RESPONSE TO PUBLIC COMMENT

Application for Landfill Expansion, Permit No. DES-SW-SP-95-001 Waste Management of New Hampshire, Inc. TLR-III Refuse Disposal Facility, Phases 15-17 90 Rochester Neck Road, Rochester, NH June 11, 2018

Below is a detail from the Design Drawings (Sheet No. 28 of 48) in the permit modification application showing a typical base liner section.

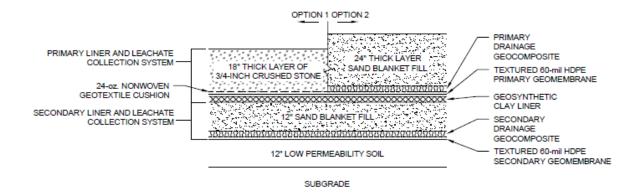
a. What kind of technology is being used for the expansion? Is the expansion going to utilize different technology than the original landfill? How has the technology improved?

The Landfill expansion must meet the design requirements of the Solid Waste Rules in effect at the time of final design plan approval and, pursuant to Env-Sw 1103.01, *General Design Requirements*, employ best practicable technology(s) and sound engineering practices in meeting those requirements. Landfills are comprised of many different parts and types of infrastructure, and there are many different ways to design a landfill to meet

the requirements of the Solid Waste Rules. NHDES has determined that the technologies proposed by WMNH can be used to meet the current design standards in the Solid Waste Rules. A brief description of liner, cap, and landfill gas collection technology proposed for the expansion is provided below.
